Re: **TR 6569 and HDP 86-04, and EIR (SCH # 2005032054)**
Soldier Field Partners, LLC
Notice of Appeal to City Council

RE: HDP86-04 Greg Woehrle (Applicant), Soldier Field Partners, LLC (Owner); LR Zoning and H-O-D - Review of Draft Environmental Impact Report

Second Party Review of
Geotechnical Aspects of
Soldier Field EIS
East Side of Burton Valley
Lafayette, California

Re: Proposed Lucas Ranch Project, Tract 6569/Soldier Field Subdivision
City of Lafayette, Contra Costa County, California

Figure 1
Lucas Ranch Project

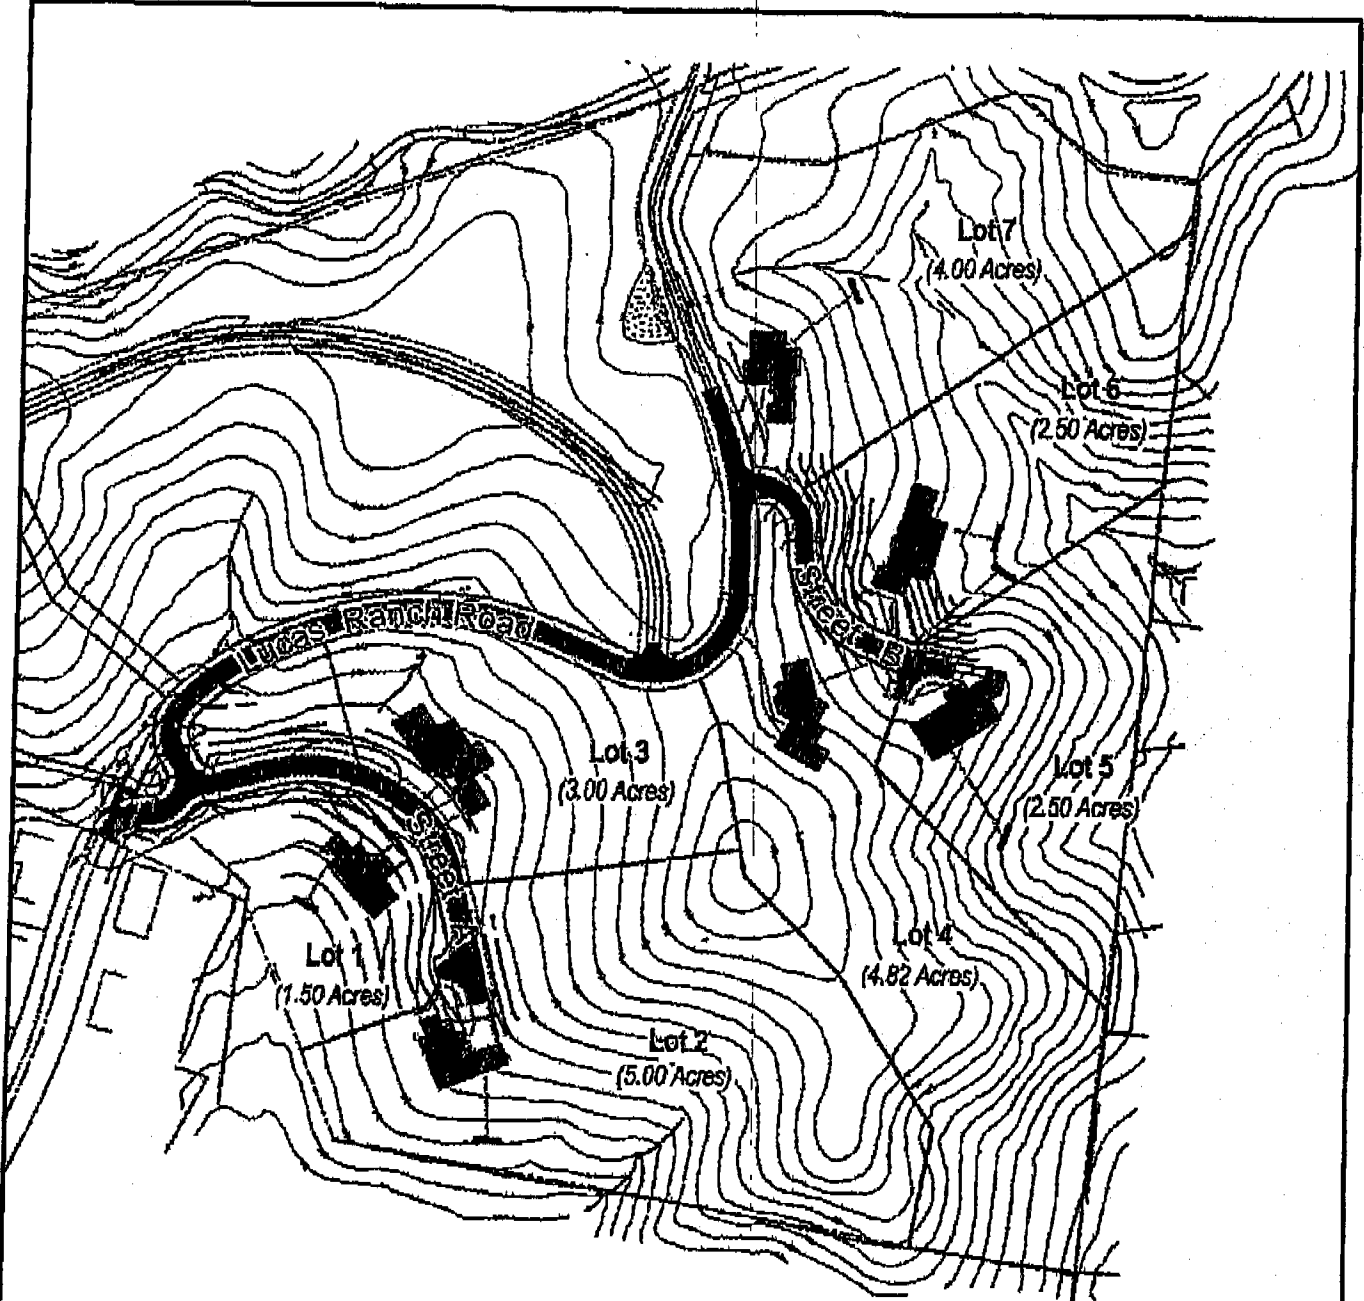
This letter is submitted on behalf of James Bradford DeLong and Ann Marie Marciarille, owners of 1 Lucas Court, Lafayette, California. This letter is a joint technical report reflecting the investigation and analysis of Todd Engineers and of Gilpin Geosciences. Todd Engineers' are licensed hydrologists, with over 25 years of experience in their area of expertise. Gilpin Geosciences are licensed geologists with over 25 years of experience. We have both conducted several site inspections. The DeLong Marciarille property is adjacent to the Lucas Ranch property proposed for development of eight new residences. A portion of the proposed development is shown on Figure 1. Lot number 2 is directly south of the DeLong Marciarille property.

Existing Conditions: The proposed subdivision is located along two intersecting ridgelines, with very steep side slopes. Upslope north of the 1 Lucas Court residence the slopes exceed 35 percent as exhibited in the Slope Analysis Map, Exhibit 6, Lucas Ranch Project Opportunities and Constraints Analysis, July 2002.

- Regrading of the slope above 1 Lucas Court should include mid slope drainage benches that capture surface runoff and collect it into drain pipes that outlet in the creek below the 1 Lucas Court Residence.
- Other slopes should be assessed for moderate to high potential debris slide hazards and appropriately mitigated.

- Permeable landscaping: open pavers for driveways and landscaping, infiltration trenches or vaults
- Energy dissipation: grade control structures such as weirs, sills, drop structures
- Rainwater collection: cisterns, detention basins, infiltration trenches
- Temporary construction: hay bales, erosion control blankets

- All stormwater collection gutters and piping sized for 25 years
- Excavation prohibited on ground slopes greater than 25 percent

- Reassess landslide areas mapped by Cal Engineering & Geology in light of recent storm related slope failures.
- Mitigation measures should include removal of active debris slide material to a depth of competent bedrock, to be replaced with well drained and compacted engineered fill.

February 2006	Figure 1 Lucas Ranch Project
TODD ENGINEERS Emeryville, California

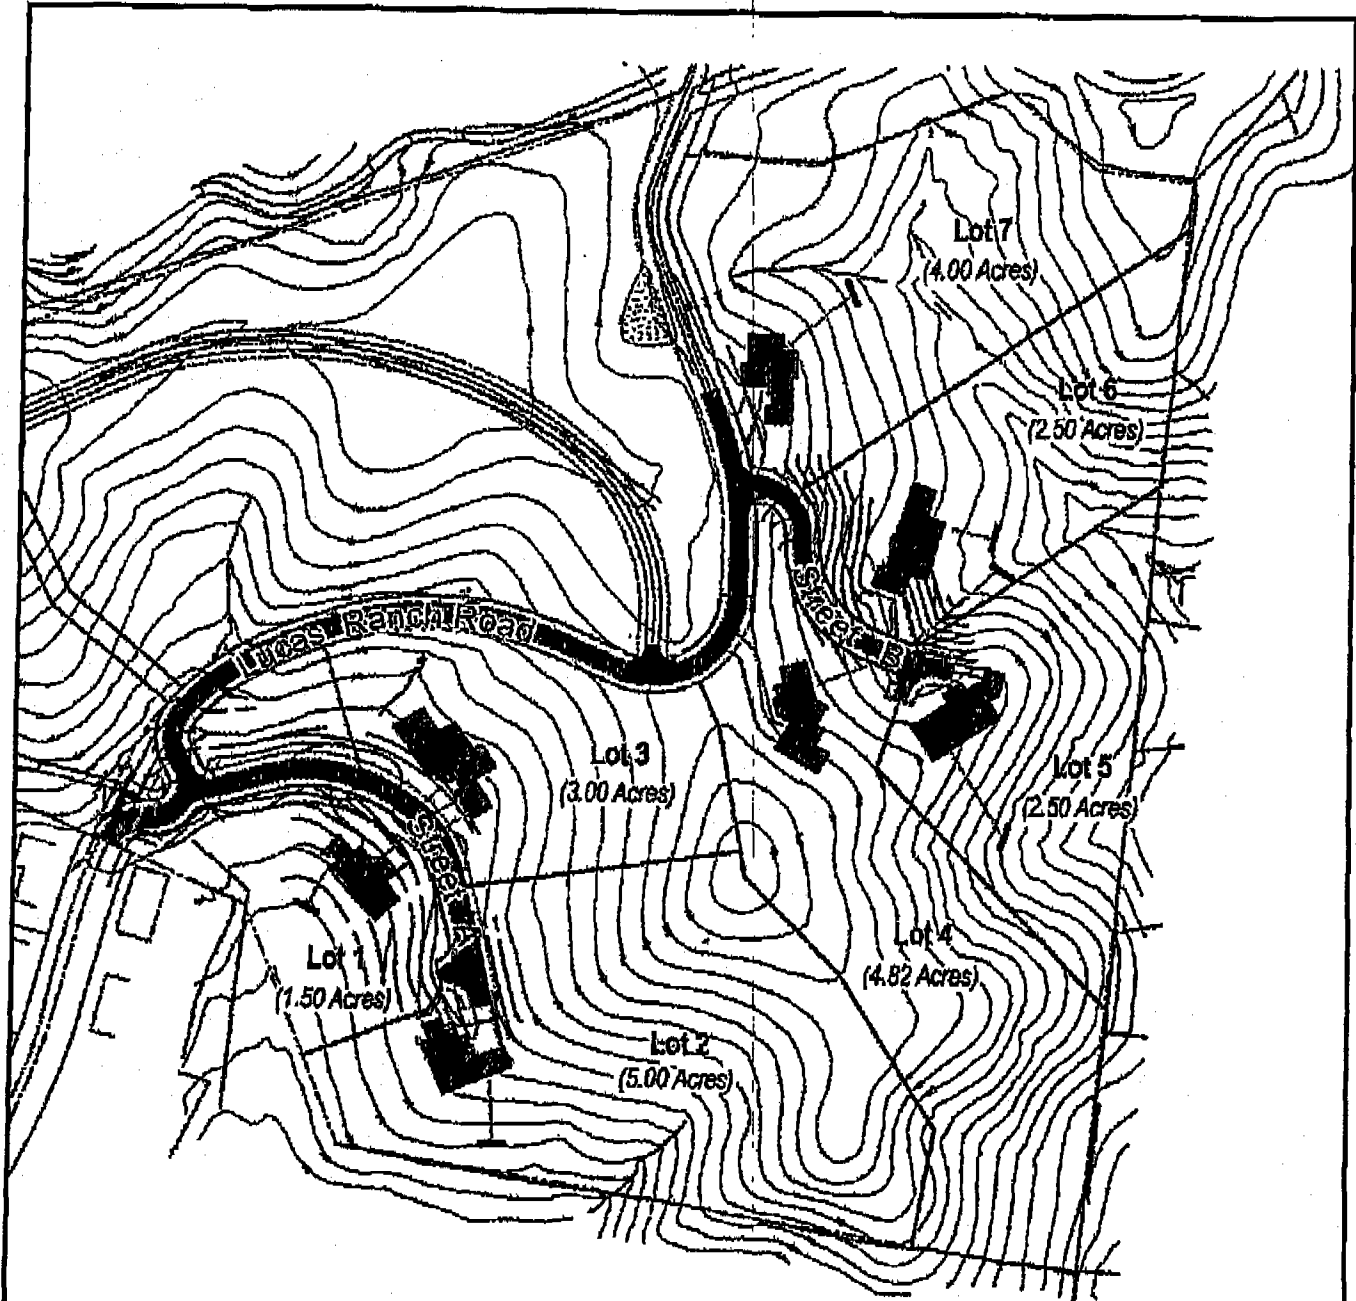
Because the proposed improvements are being developed as Low Density Residential, which requires average 1 unit per 5 acres, we believe there is a need for there to be a Homeowners Association (HOA) or an Improvement/Assessment District designated area of influence that will require monitoring of drainage and slope stability performance of the development over the life of the project. This monitoring would provide periodic inspections and maintenance of the surface drainage and the stormwater control systems to minimize the impact of heavy precipitation events on the downslope neighborhoods.
